|||||LINCOLN ROAD DISTRICT

**HISTORIC PRESERVATION BOARD
REVISED APPLICATION**

05/14/2024

LINCOLN ROAD DISTRICT IMPROVEMENTS PHASE 3

EUCLID OVAL PAVING
PRECAST CONCRETE HEX PAVER ALTERNATIVE (05/14/2024)

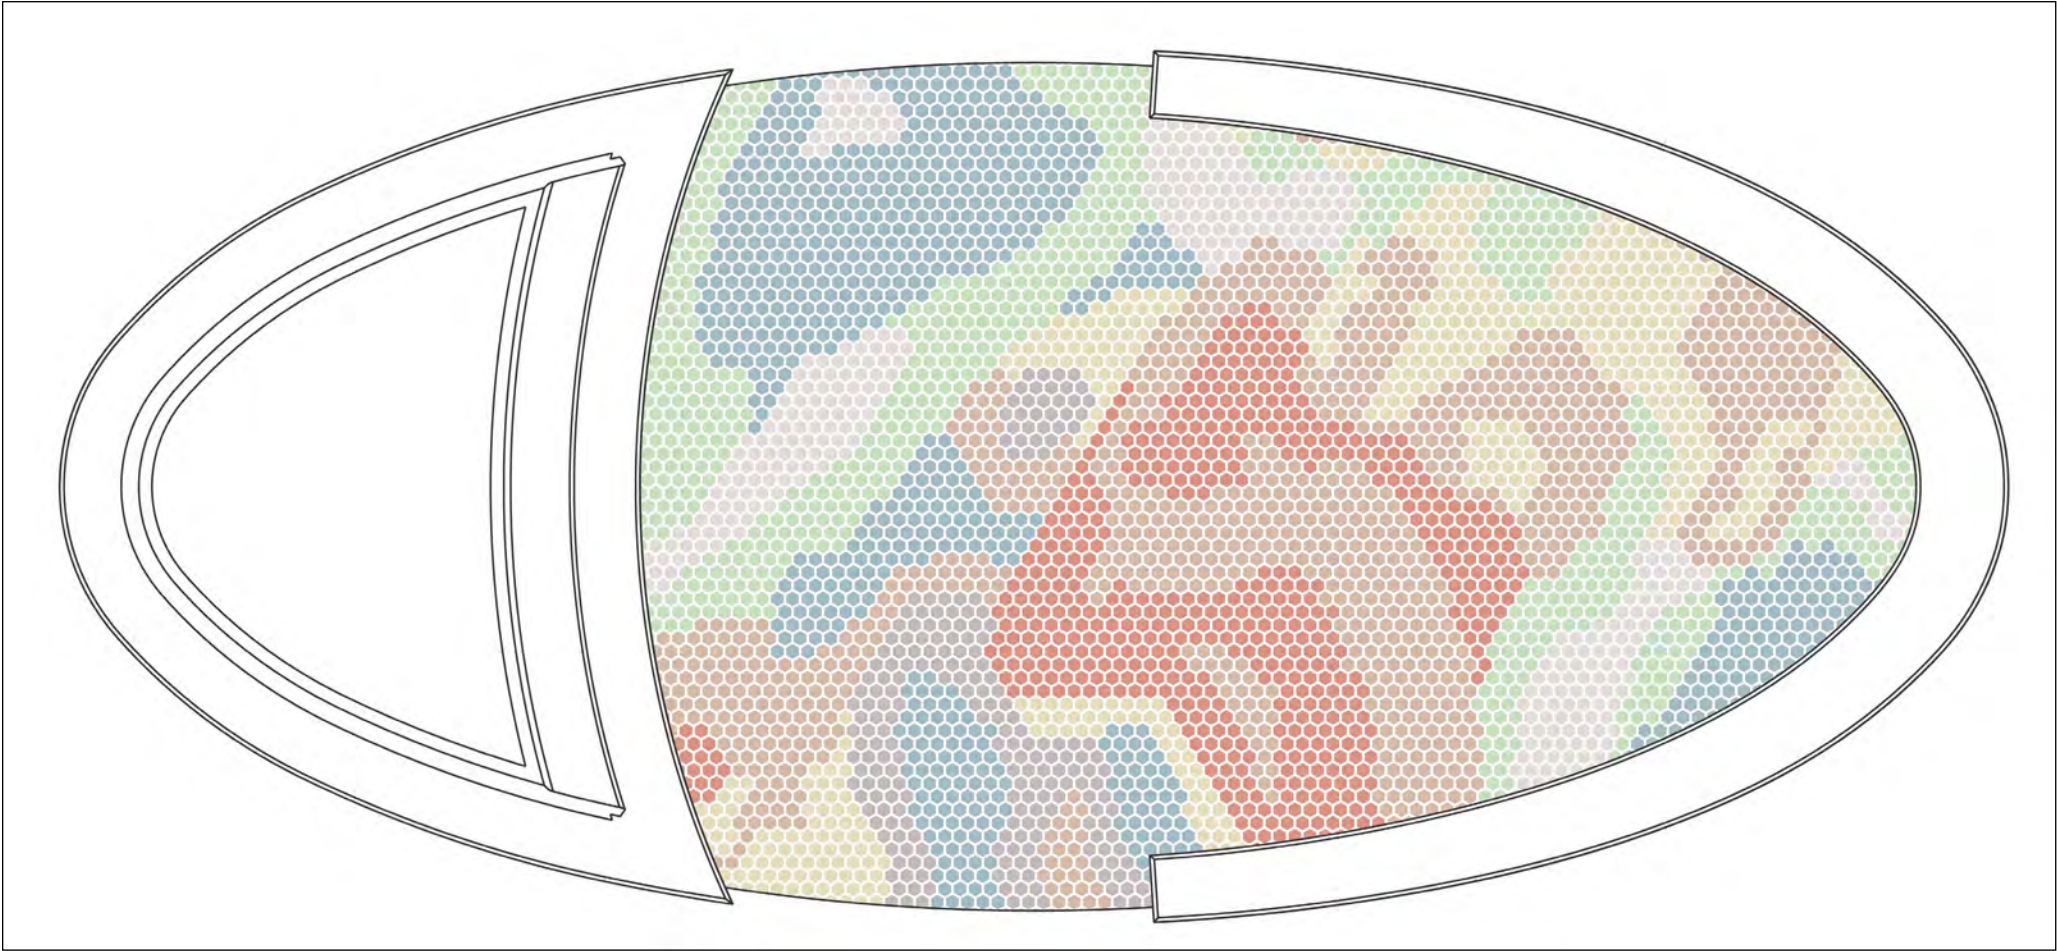
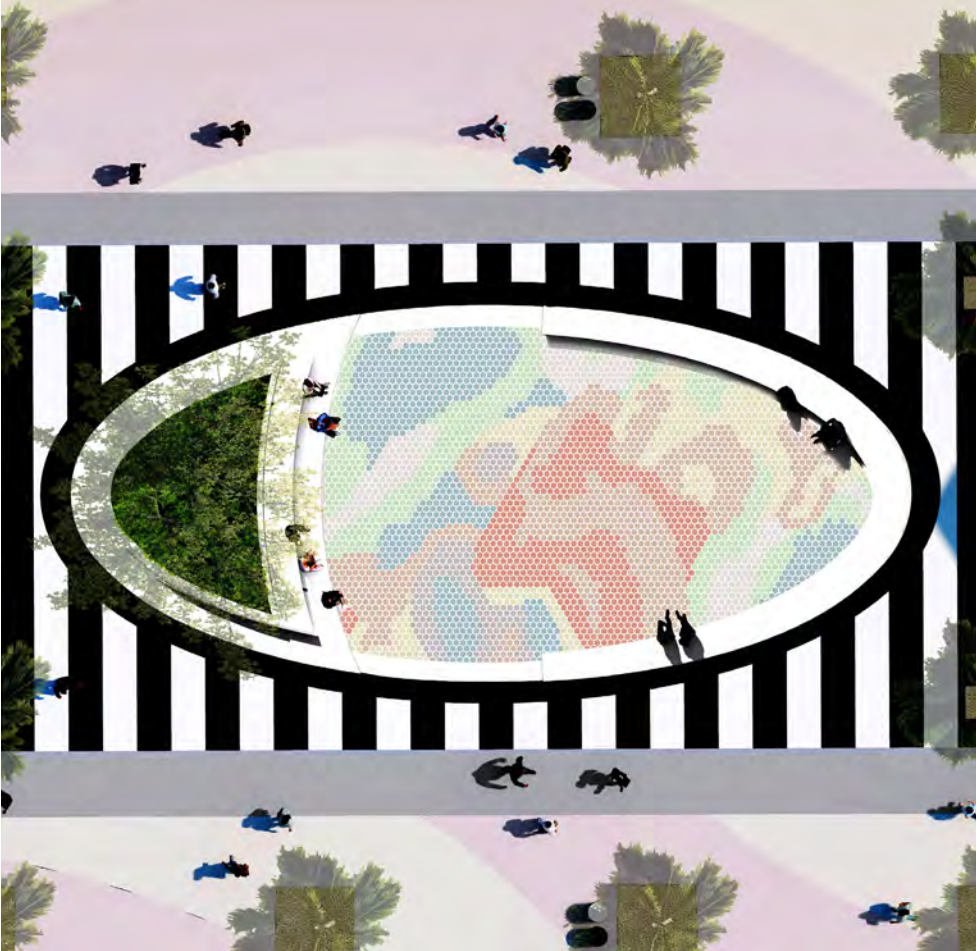
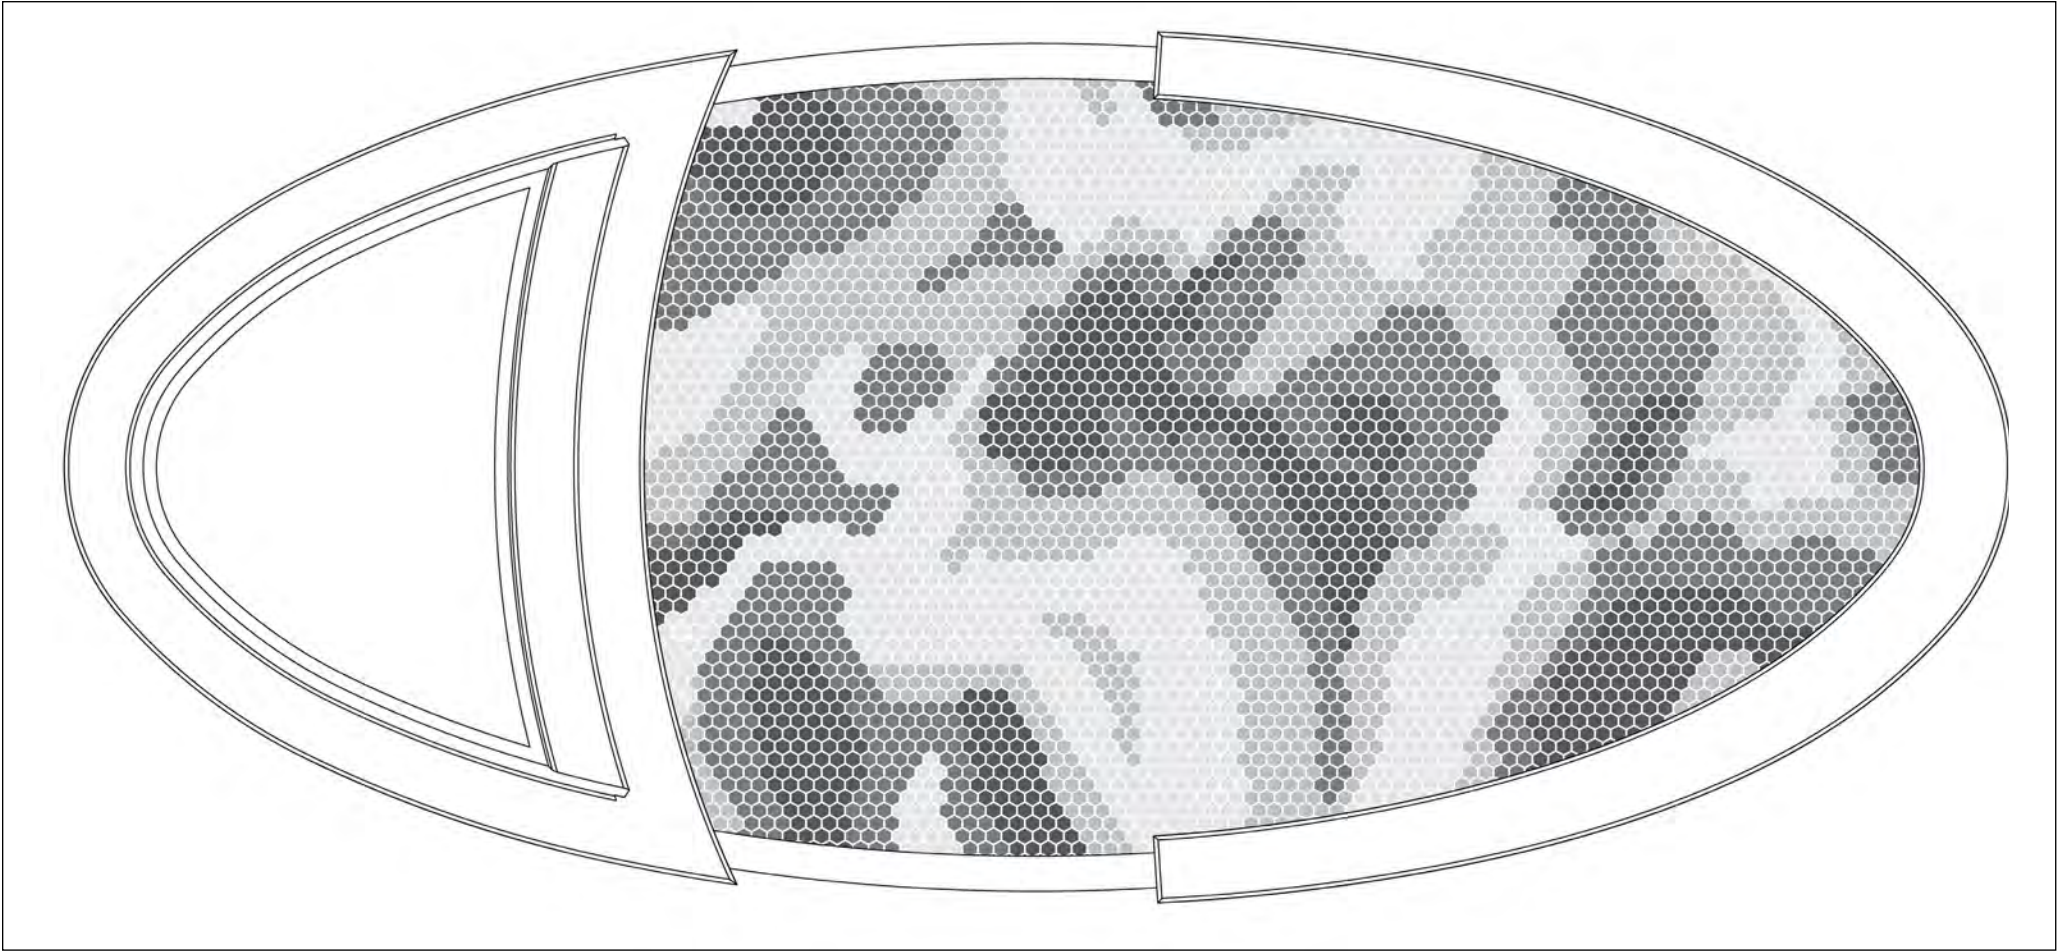
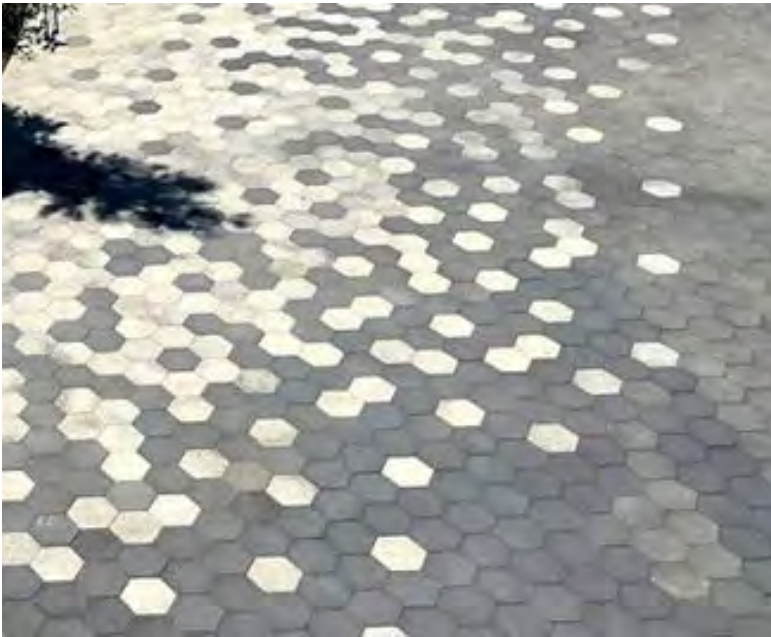
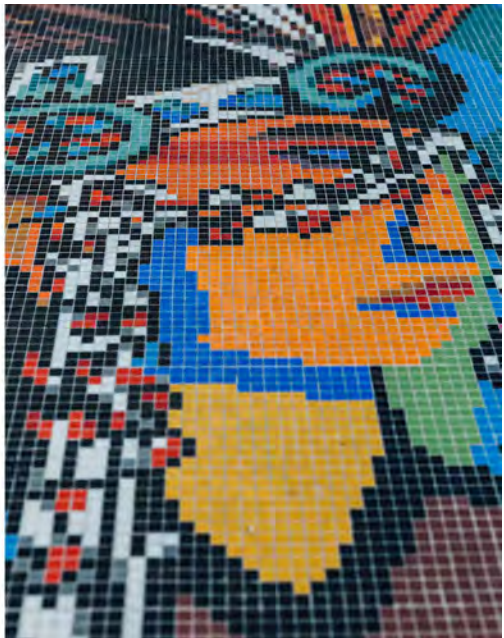
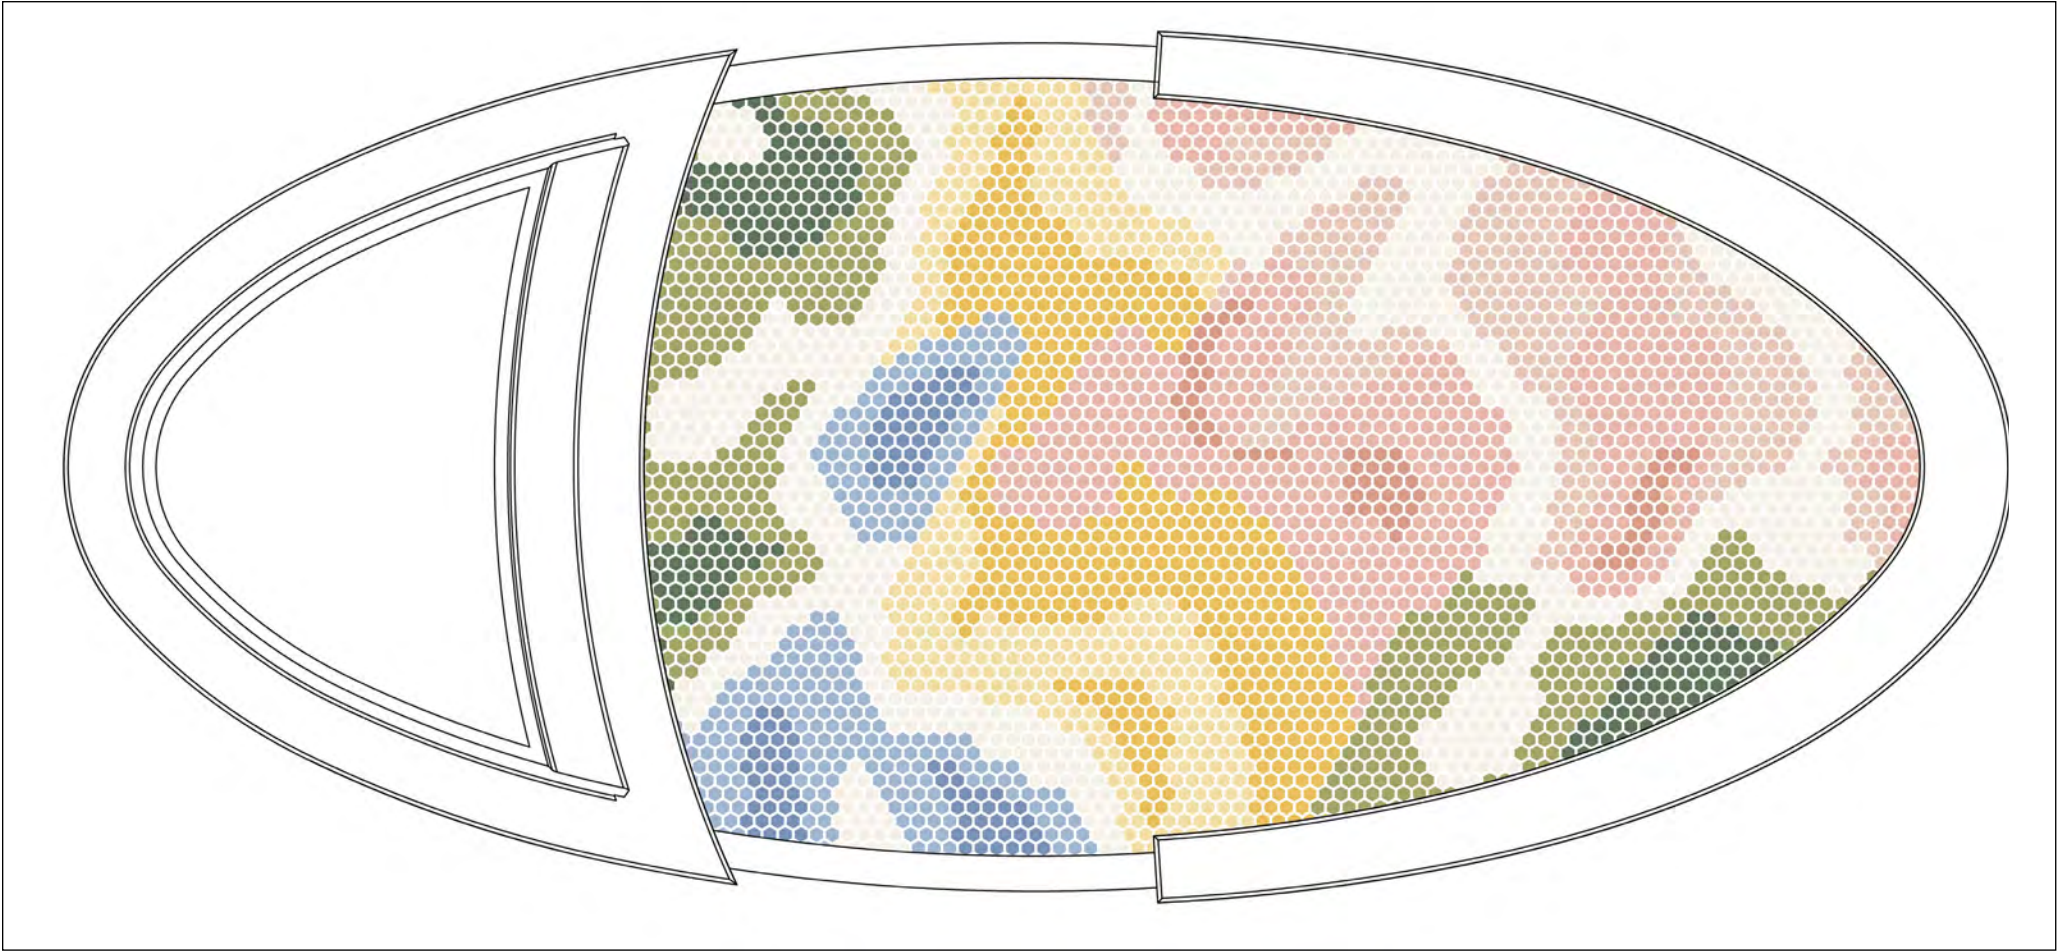
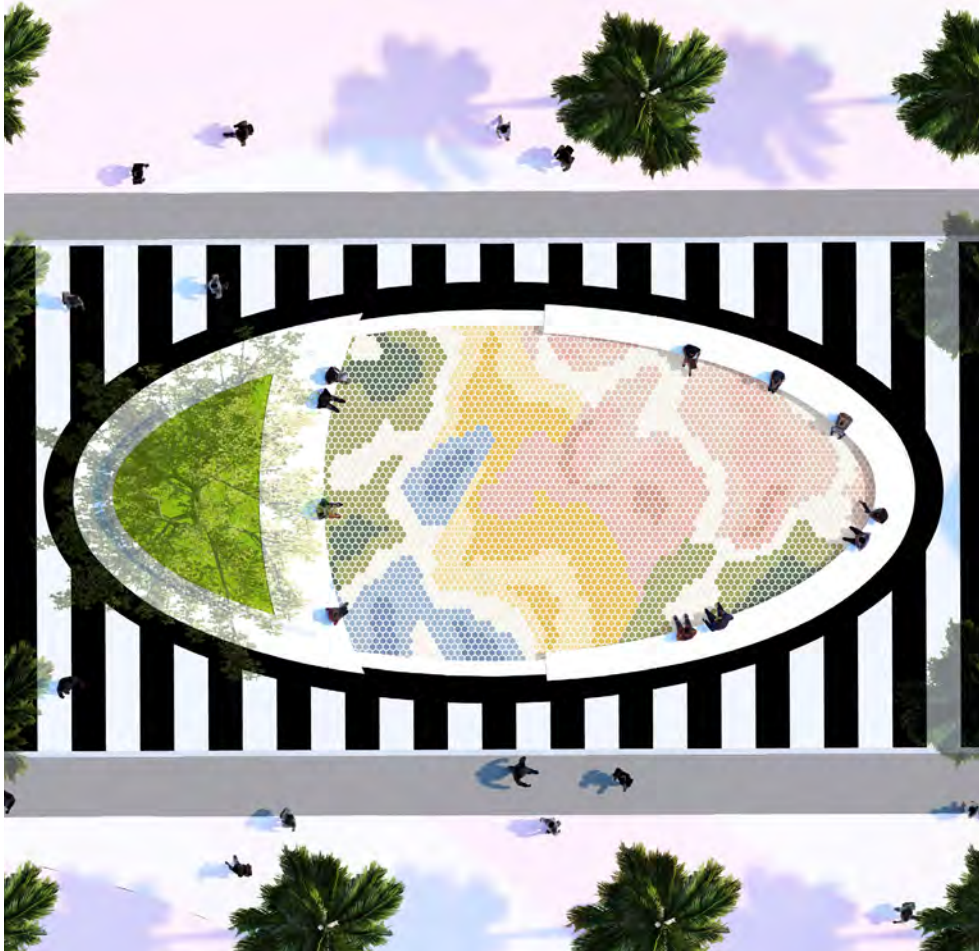
PAVING- CONSIDER OTHER MATERIAL ALTERNATIVES TO PROPOSED CERAMIC TILE

EUCLID OVAL PAVING
OPTION 2- 8" HEXAGONAL PRECAST CONCRETE PAVERS (05/14/2024)

EUCLID OVAL PAVING
OPTION 3- 8" PRECAST CONCRETE HEX PAVER (05/14/2024)

OPTION 4- 1/2" X 1/2" CERAMIC MOSAIC (05/14/2024)

EUCLID OVAL PAVING
OPTION 5- 1/2" X 1/2" CERAMIC MOSAIC (05/14/2024)
